CITY PLANNING COMMISSION

APPLICANT	MORTON & PITALO, 1430 Alhambra Boulevard #200, Sac., CA 95816				
OWNER	BROPHY DEVELOPMENT CO. 5620 Birdcage St. #150, Citrus Heights, CA 95810				
PLANS BY	MORTON & PITALO, 1430 Alhambra Boulevard, #200, Sac., CA 95816				
FILING DATE	2/24/88	ENVIR. DET.	Neg Dec	REPORT BY	DH:vf
ASSESSOR'S PCL. NO.	237-0200-08,53,54,83

- APPLICATION:
- A. Negative Declaration
 - B. Special Permit to develop a 101 unit mobile home park on 14+ vacant acres in the R-2A zone.
 - C. Lot line adjustment to merge four vacant lots into one lot of 14+ acres.

PROPOSAL: The applicant is requesting the necessary entitlements to develop a 101 unit mobile home park.

SITE PLAN - JESSIE AVENUE MOBILE HOME PARK

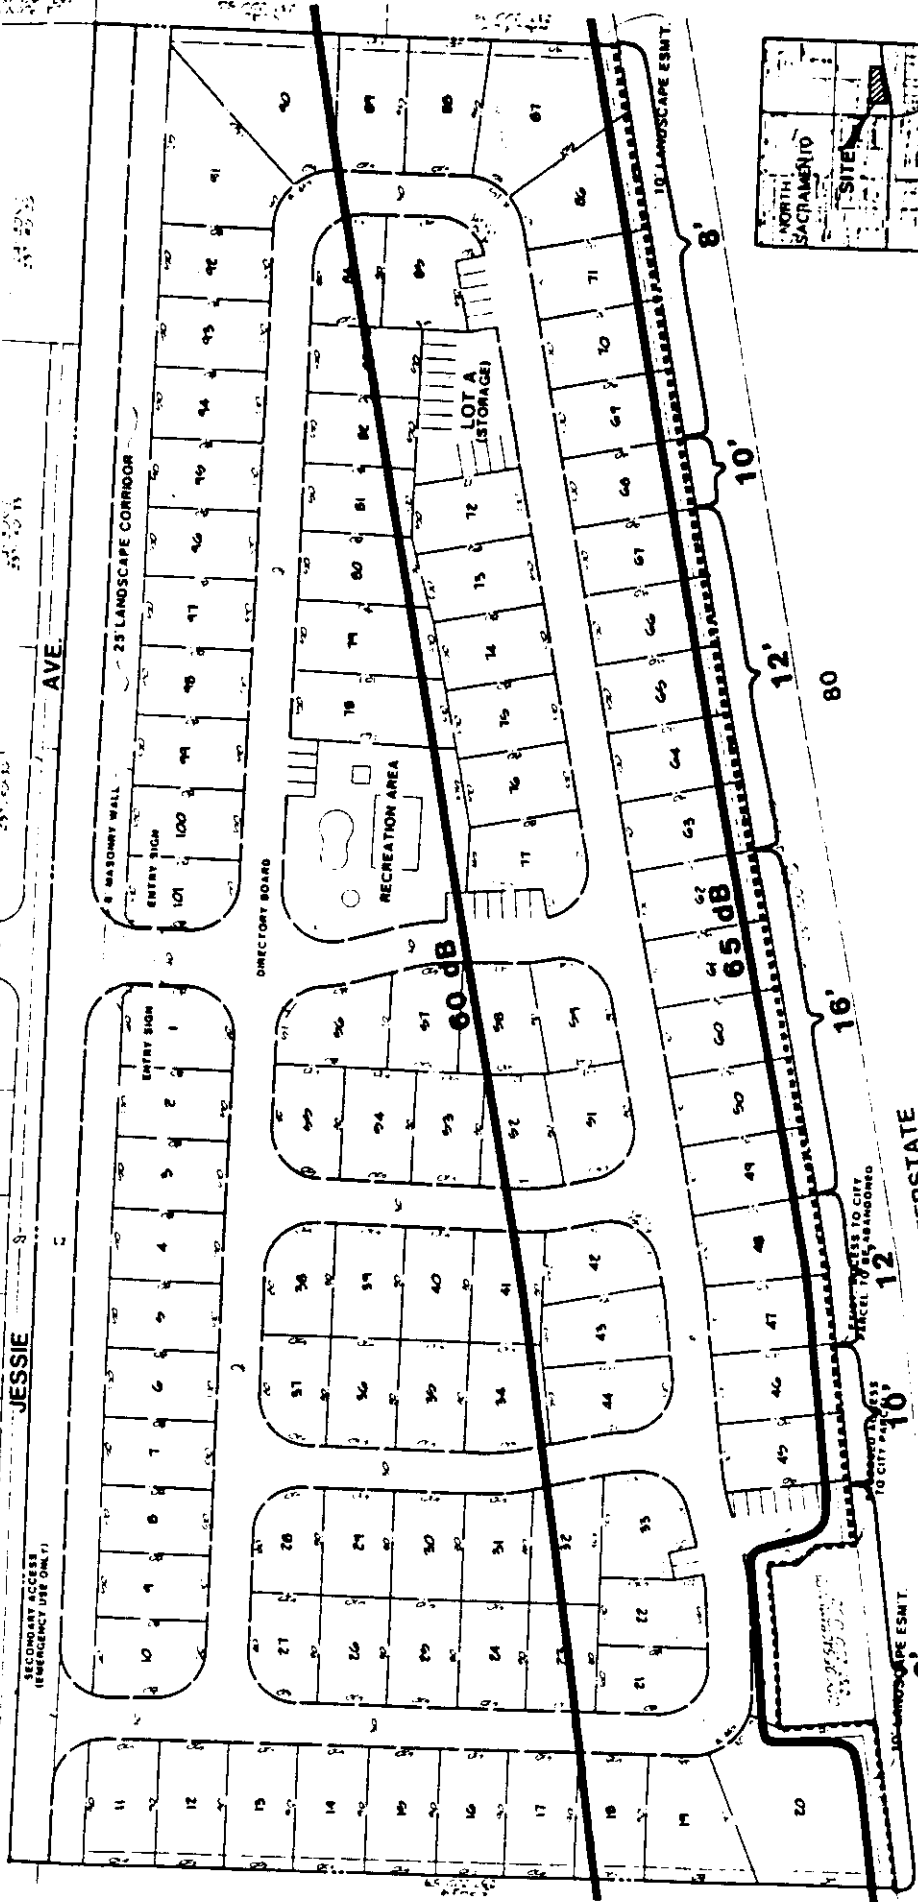
4. Noise barriers should be provided as illustrated in Figure 2. Specifically, an eight foot high wood barrier should be provided from Lot 20 to the west edge of Lot 45. Lots 45 and 46 should be provided with a 10 foot high barrier. Lots 47 and 48 should have a 12 foot barrier and should be provided for Lots 63-67. The barrier at Lot 68 should be 10 feet high. Lots 69-71 and 86-87 should be provided with an eight foot barrier. All barrier heights are relative to pad elevation. The barrier is to be located along the south project boundary as illustrated in Figure 2.

analyzed a system of noise barriers could reduce on-site noise levels to 65 dB Ldn or less. Barrier heights would range from 8 feet to 16 feet in height. (See Figure 2 for barrier location and heights).

- d. Noise barriers should be provided as illustrated in Figure 2. Specifically, an 8-foot high sound barrier should be provided from Lot 20 to the west edge of Lot 45. Lots 45 and 46 should be provided with a 10-foot high barrier. Lots 47 and 48 should have a 12-foot barrier should be provided for Lots 63-67. The barrier at Lot 68 should be 10 feet high. Lots 69-71 and 86-87 should be provided with an 8-foot barrier. All barrier heights are relative to pad elevation. The barrier is to be located along the south project boundary as illustrated in Figure 2.

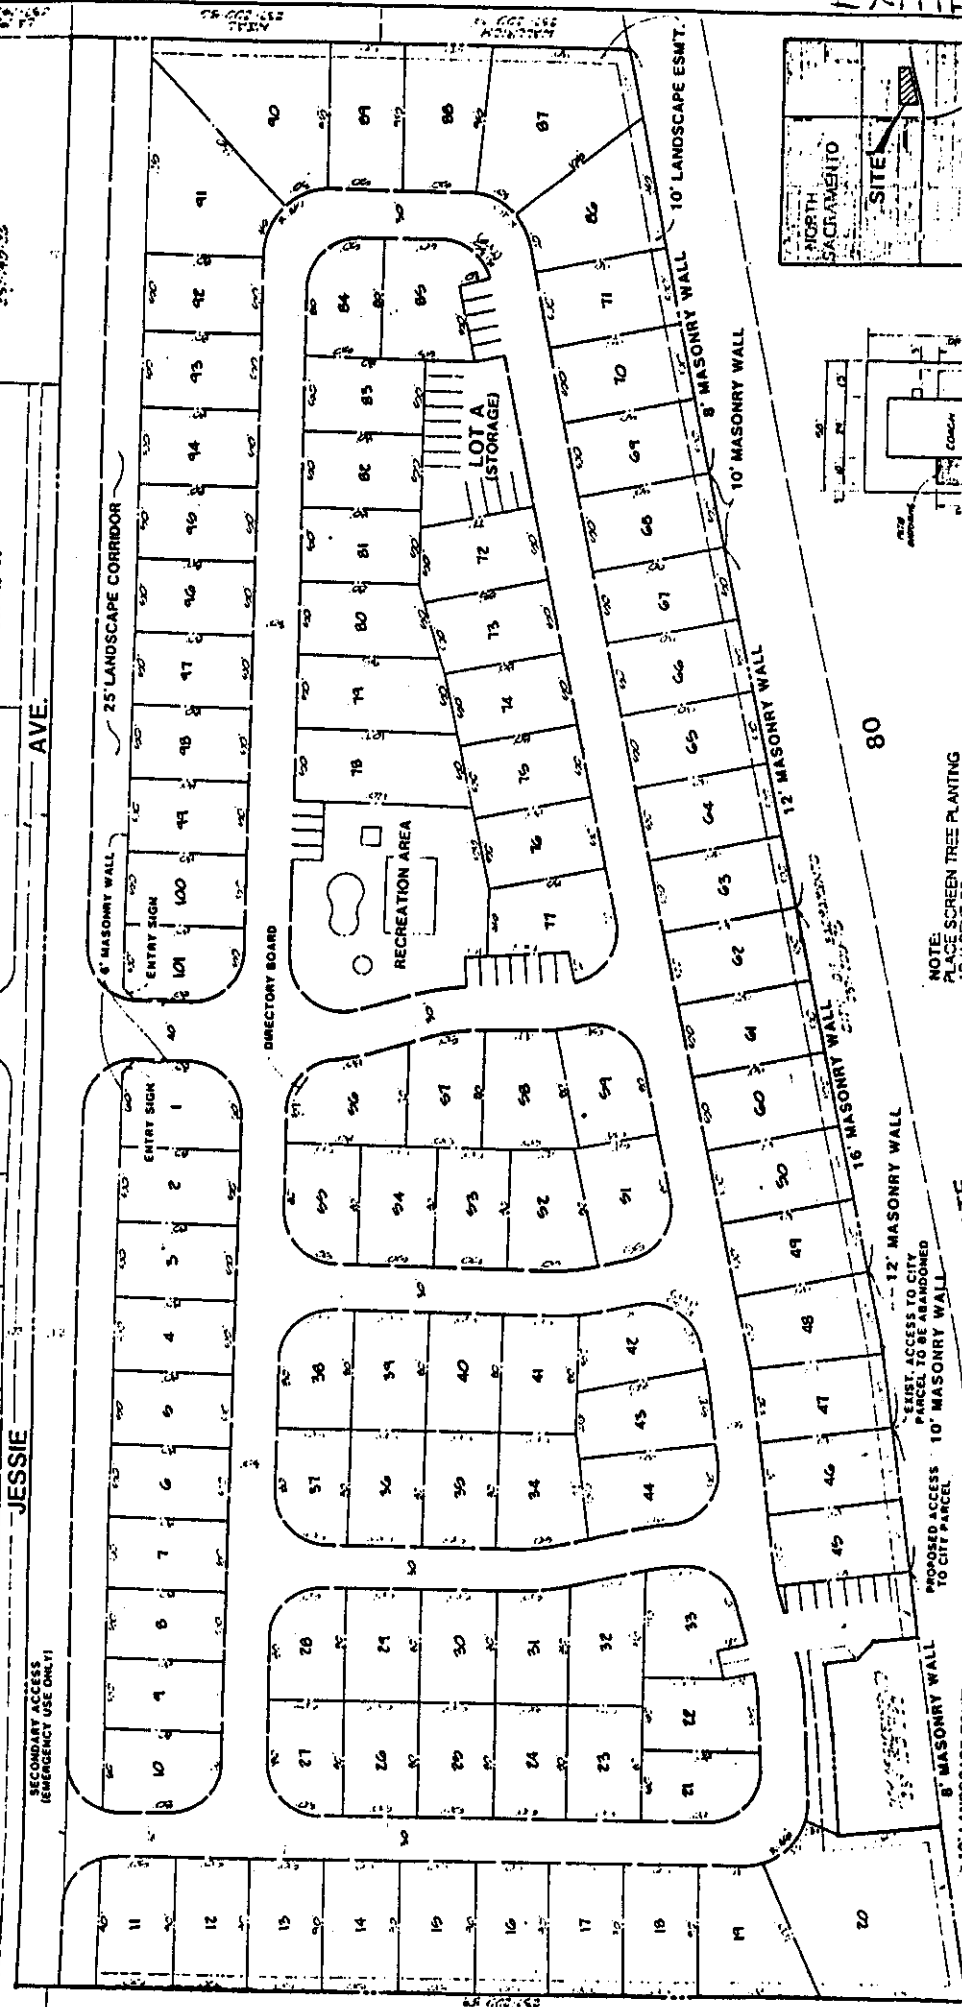
1. Street pattern: The main entrance off Jessie Avenue may require redesign to follow the location of existing water, sewer or storm drainage facilities. If this is necessary, the redesign of lots along May Street into the mobile home park will be required and wherever the 84 inch storm drainage line exists.

2. Lighting - No street lighting plans were shown. Street lights along Jessie Avenue will be required with street improvements. Interior street lights should be electrolier type fixtures and not flood lights.

3. Fire water supply - Two fire hydrants should be shown on the site meeting the approval of the Fire Marshall's Office. Water supply of 1,000 gallons per minute is required for residential development.

4. Jessie Avenue Street Improvements - Standard curbs, gutter and sidewalks with standard half street will be required on the south side of Jessie Avenue the length of the project. The revised site plan shall show the locations of street improvements after dedication of additional right-of-way. Twelve feet of pavement will be required on the north side of the Jessie Avenue center line.

5. Utility Easements - The revised site plan should show all utility easements including any in May Street and SMUD's easement along the south property line. Any walls or structures will be required to observe the easements.

6. Signage - Staff recommends that one mobile home park identification sign be allowed at the entrance, not two as shown. The sign should be externally illuminated and not internally illuminated which would provide glare onto neighboring residential uses. Staff recommends that a detailed signage program be reviewed and approved prior to issuance of sign permits by the Planning Director. No freeway oriented signs are to be allowed.

7. Emergency access - The secondary access should be fenced with a decorative wrought iron gate with a pass key given to the Fire Department for emergency use. The applicant wishes to retain one entrance to control security into the park.

9. Plot Plan - Staff notes that the plot plan provided by the applicant for a typical 50 x 80 foot space is not drawn to scale. Staff recommends that detailed plot plans for each space be prepared showing the placement of single, double or triple wide units observing the required setbacks and landscape easements and utility easements. This master plot plan is to be prepared as part of the building permit package submitted to the State and City Building Inspection Divisions. Placement of mobile homes will be required to observe all easements.

11. Visitor Parking - All guest or visitor parking should be clearly marked. Where visitor parking abuts a mobile home space, a four foot planter strip or fence should be provided a minimum of four feet in height to prevent headlights or vehicle exhausts from creating a nuisance.

16. Storage Lot A Screening - Staff notes that the proposed storage lot A does not show fencing. Staff recommends a solid view obscuring fence be constructed around the site with gates adjacent to the street to provide security. The parking area is to be paved with an all-weather surface. Staff recommends relocating the storage area to be near the recreation facility so that the storage area would provided a buffer from the noise associated with the swimming pool.

1. The applicant shall prepare a revised mobile home park site plan for the review and approval of the Planning Director prior to submittal to the State Department of Housing and Community Development. The revised site plan shall show the following modifications:

- a. May Street access south of Jessie Avenue is to observe the 84 inch storm drain line. No mobile home or structure are to be placed over the storm drain pipe easement;

- b. street lights will be required along Jessie Avenue. Interior street lighting should be electrolier type fixture;
 - c. fire hydrants locations and water supply are to be reviewed and approved by the Fire Marshall's Office. A minimum of two hydrants are to be provided on-site;

- d. the revised site plan shall show all utility easements. Any structures including walls or fences shall respect the easements;
2. Standard street improvements along Jessie Avenue shall be required to the satisfaction of the City Engineer;
